Public Works Planning Board

WATER SYSTEM STORAGE TANK EVALUATION

Southborough, Massachusetts

DECEMBER 2016
REVISED FEBRUARY 2017
REVISED APRIL 2017

- **Park Central high elevation located in Westboro**

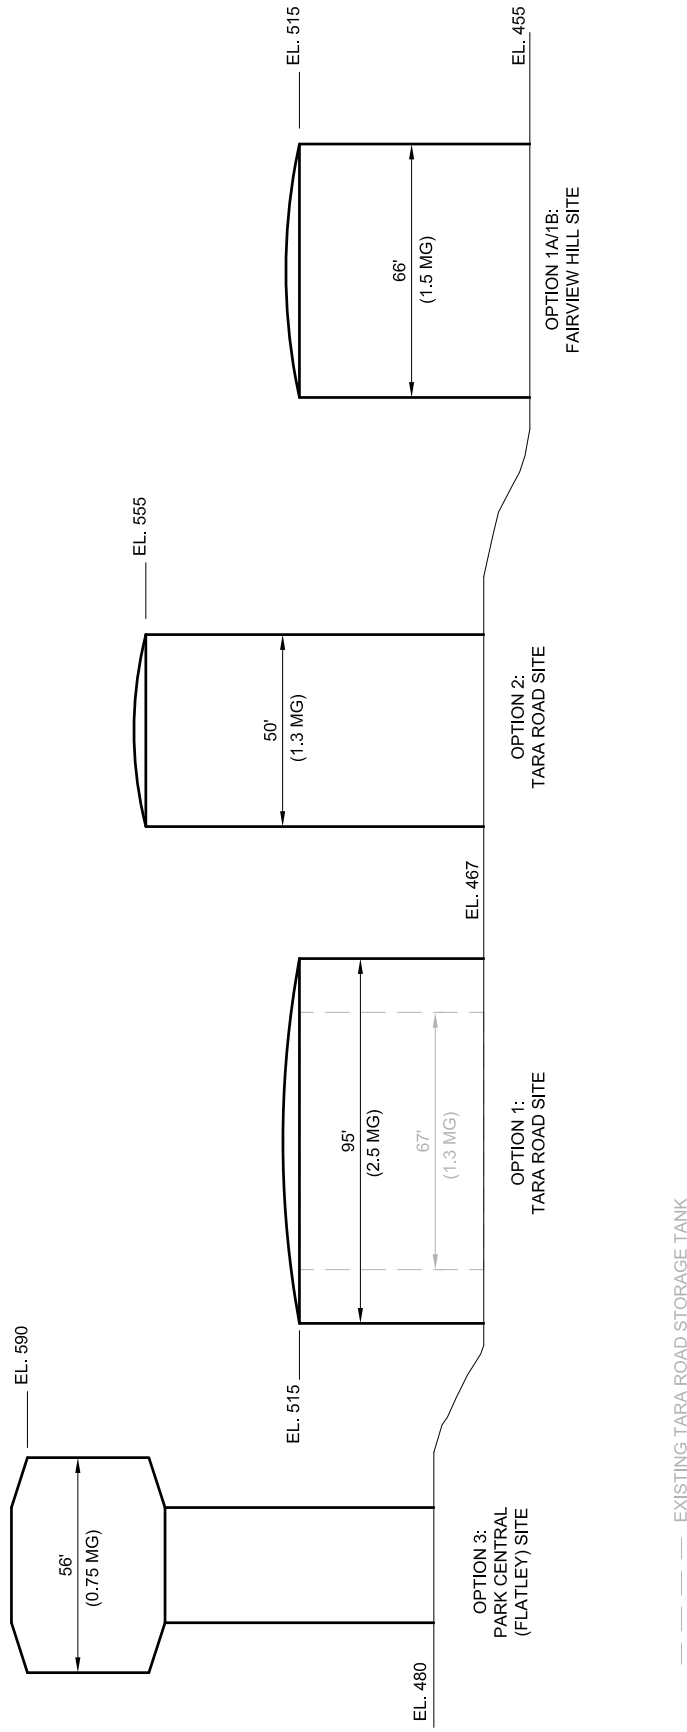
- The report states that the highest elevation of the Park Central property is in Westboro and lists this as a disadvantage of the Park Central option. This is new information not presented at previous meetings. A review of the USGS map does not appear to support this.
